### Staff Report

#### **Conditional Use Permit: Hotel Saint Bernard 112 Sutton Place**

## **Taos Ski Valley ‘Hotel St. Bernard’ Redevelopment**

Conditional Use Permit and Certificate of Compatibility Application Narrative

## Eating & Drinking Establishments: Chalet Mayer

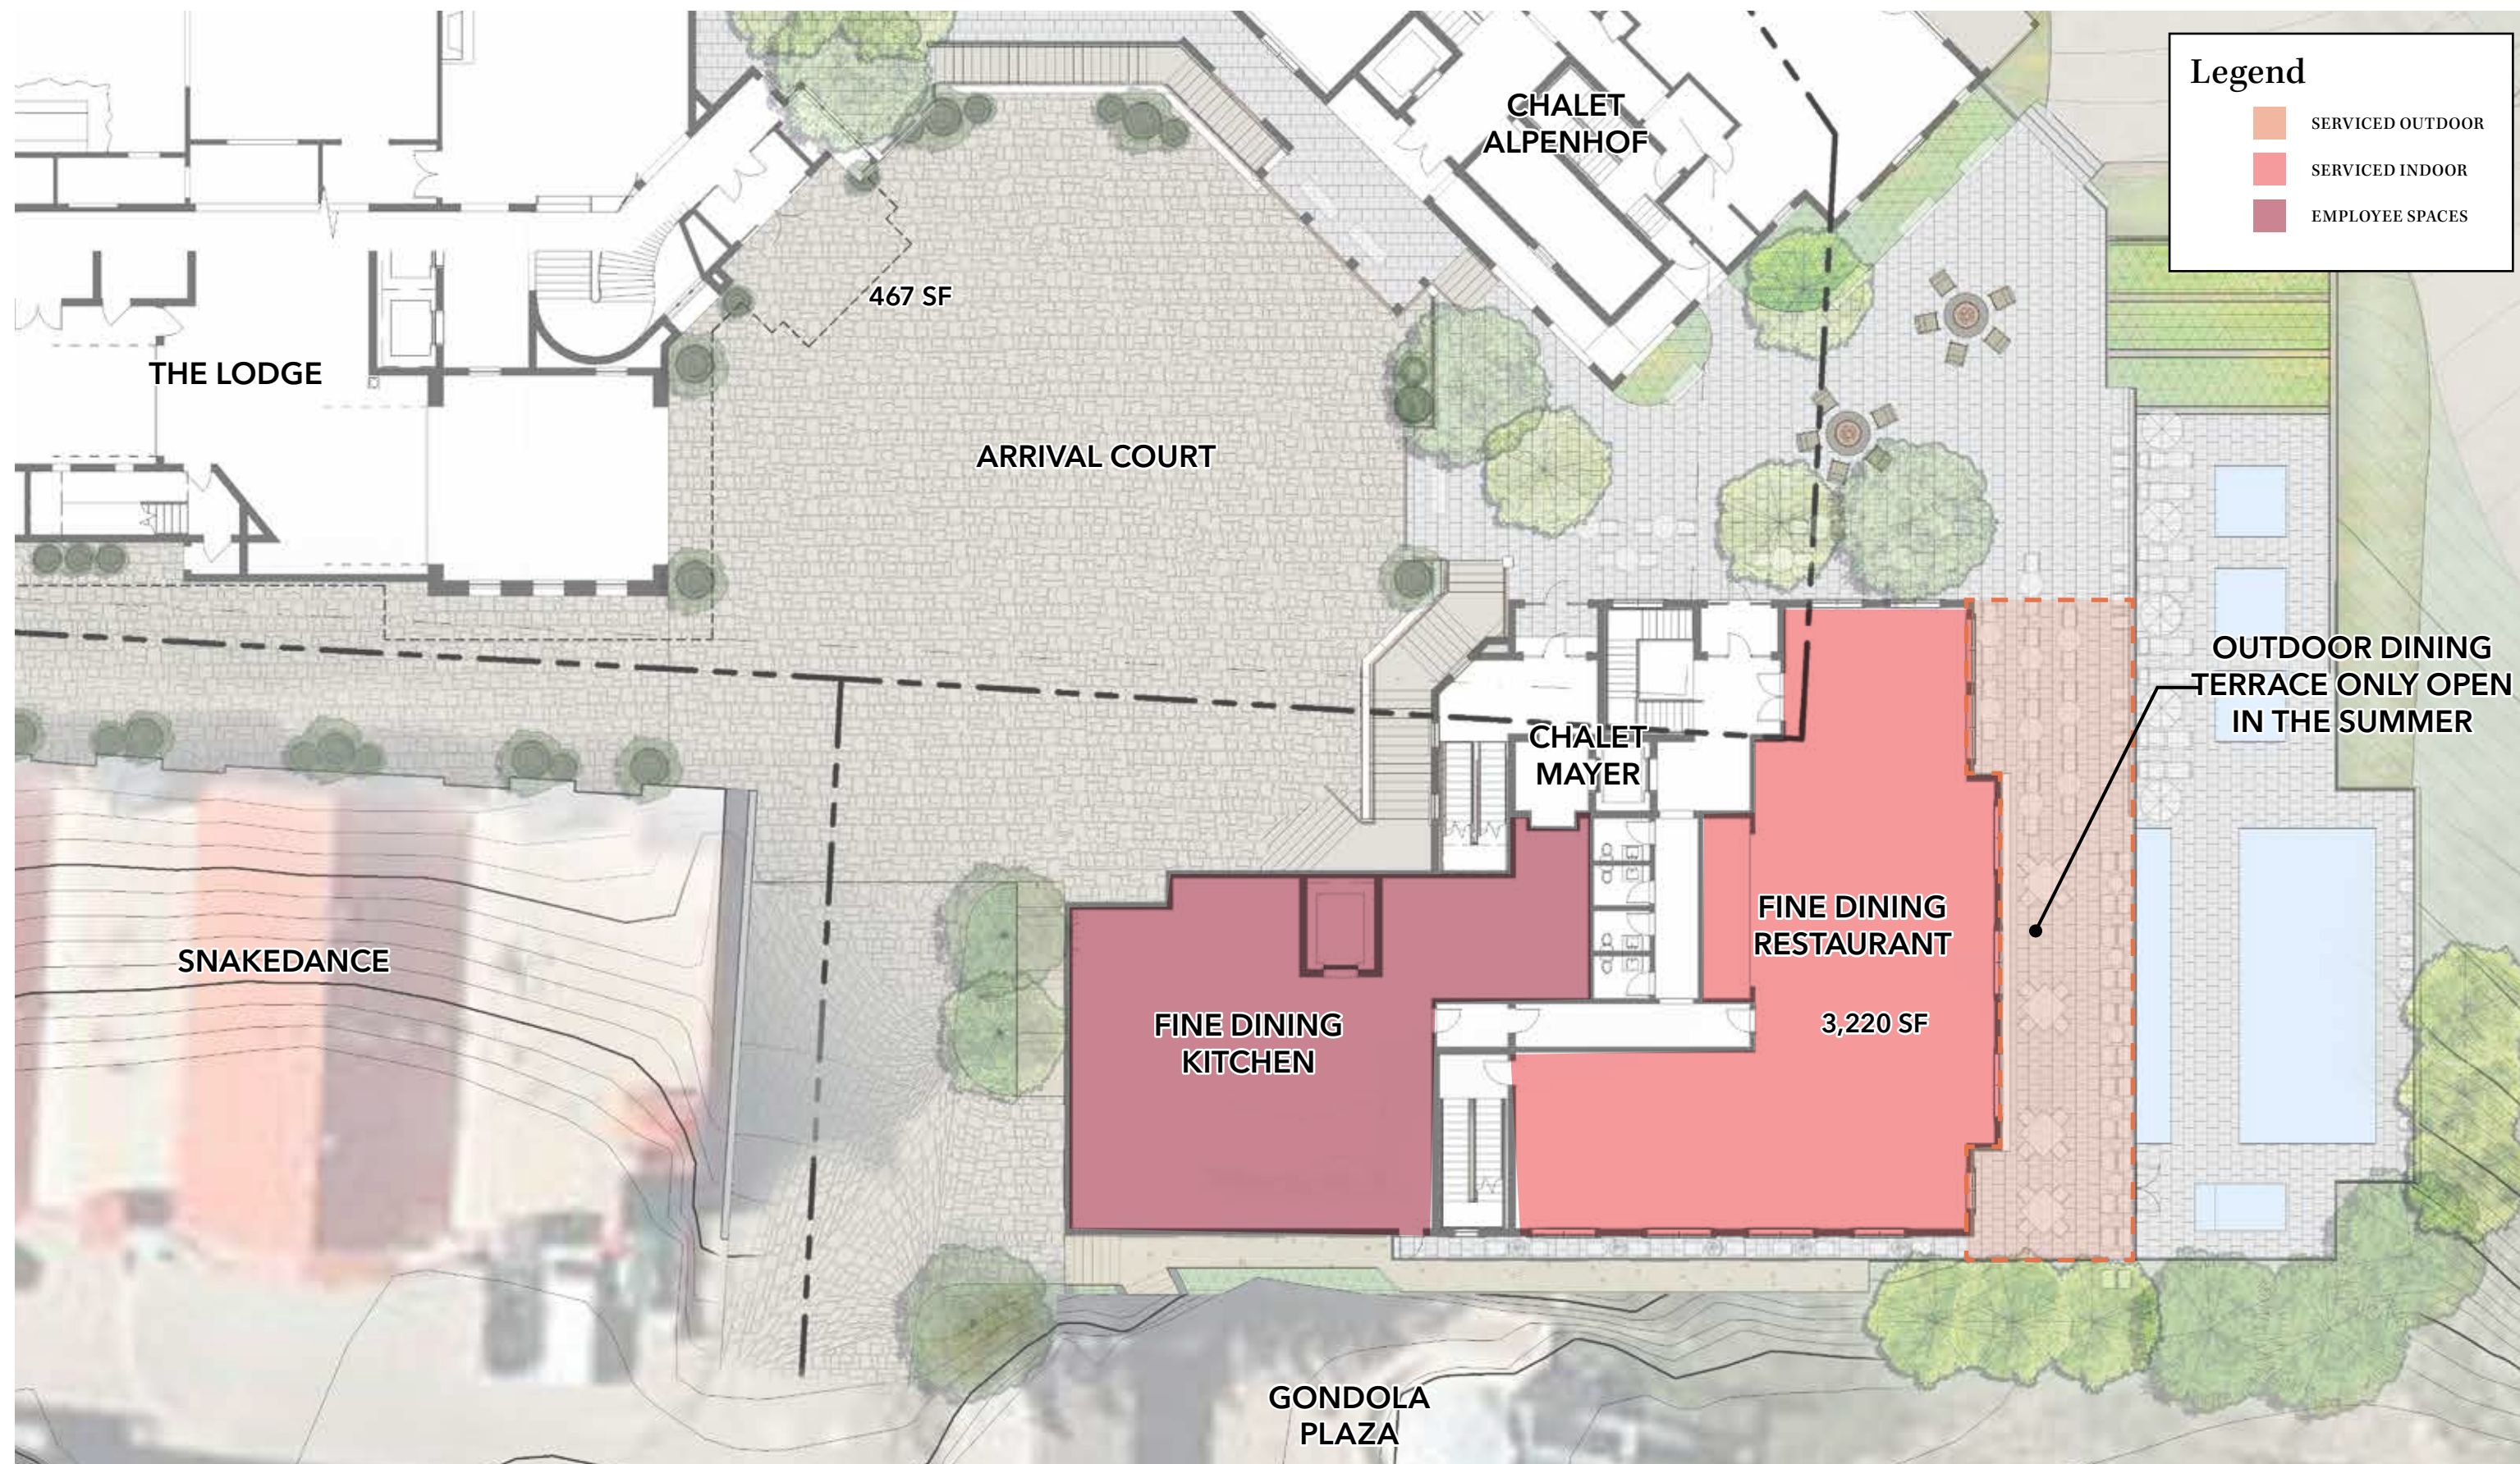
REVISED SF,  
PREVIOUSLY 9,000 SF

REVISED EATING & DRINKING SF DETAIL

Map 7 – Avalanche Zones

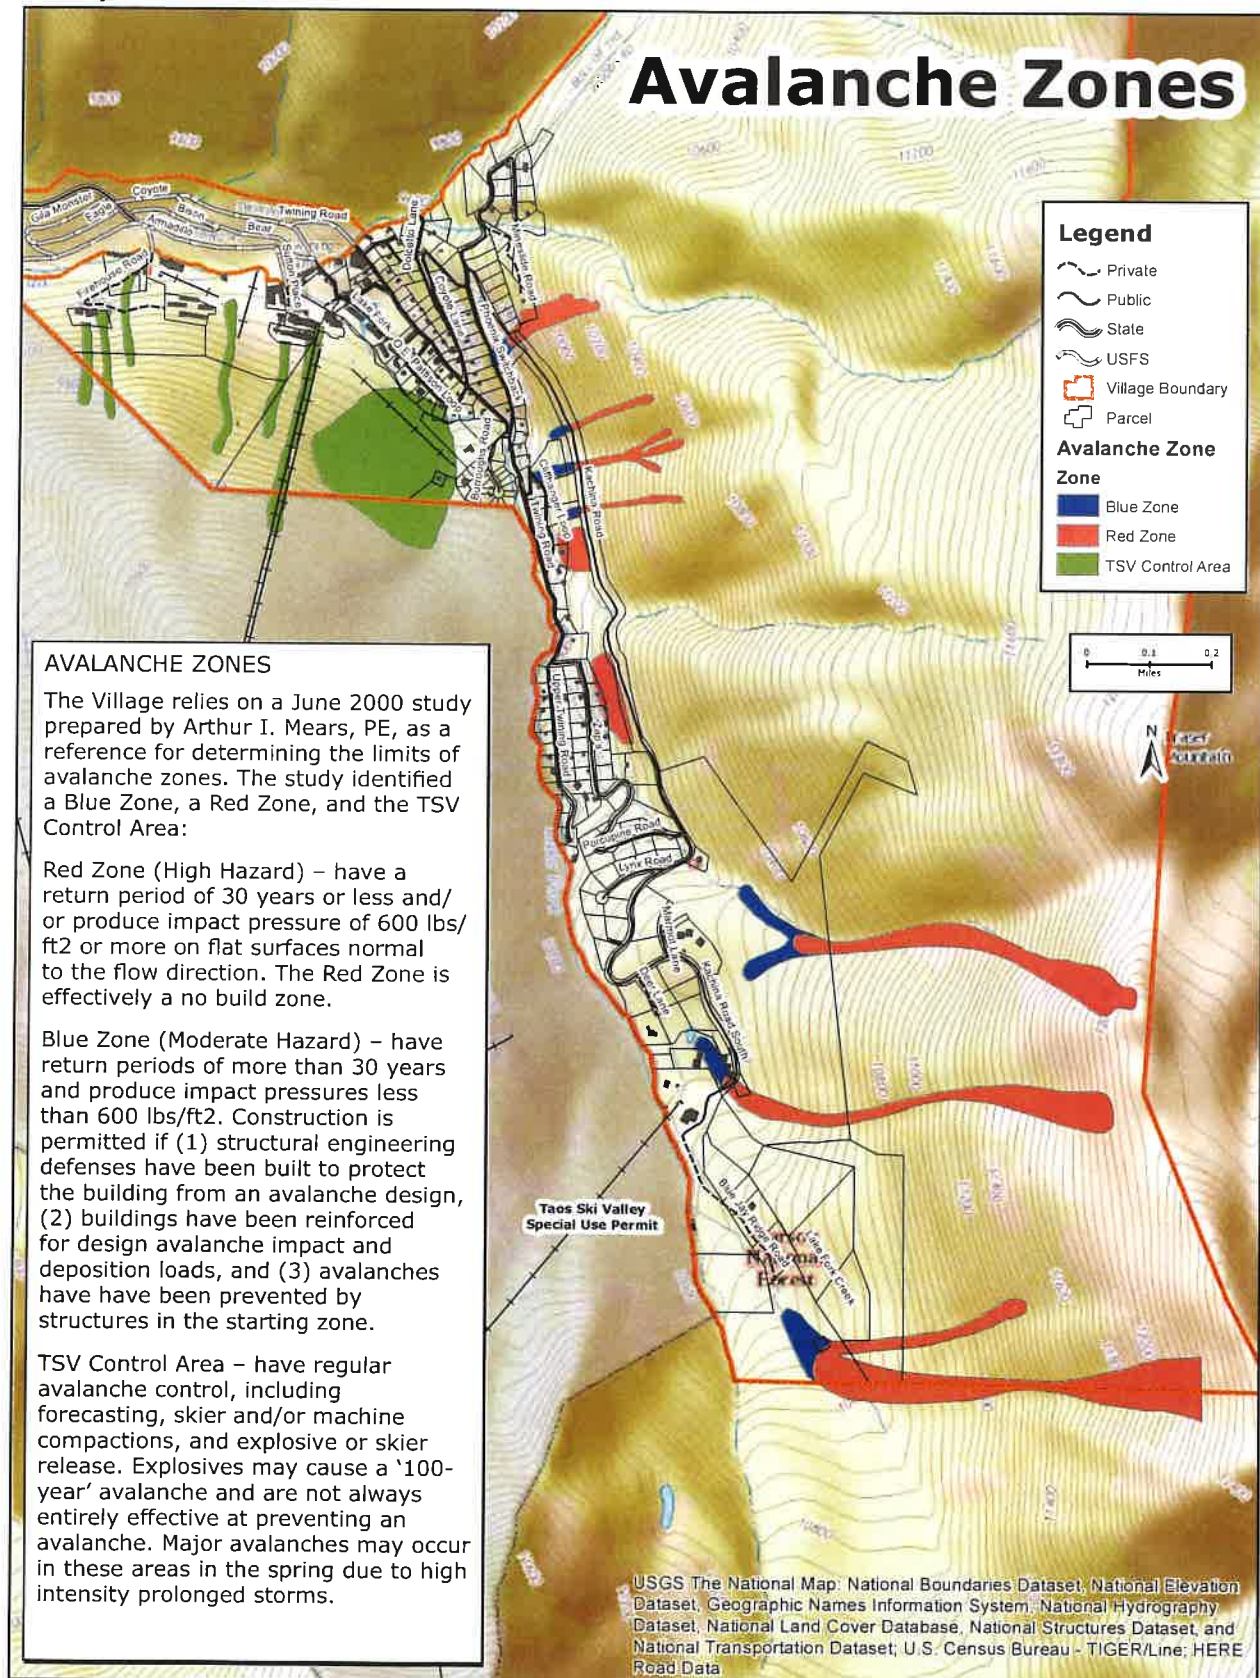
The area in question is part of the zone referred to as "The Lower Front". The attached screenshots from our GIS mapping application (SmartMountain), show some of the avalanche start zones and paths that are somewhat tangential to the area of the mountain that can potentially affect the St. Bernard. The "compaction" attachment has an area outlined in red, this zone receives early season ski packing, and machine packing in the lower angled terrain just above the hotel. We forecast hazard, ski check, ski cut, and ski-in the additional layers of storm snow until we are able to open the terrain. Re-opening after subsequent storms may require ski cutting and very rarely explosive application. Small, loose storm snow avalanches that are relatively harmless, and do not travel far, are the most common type triggered.
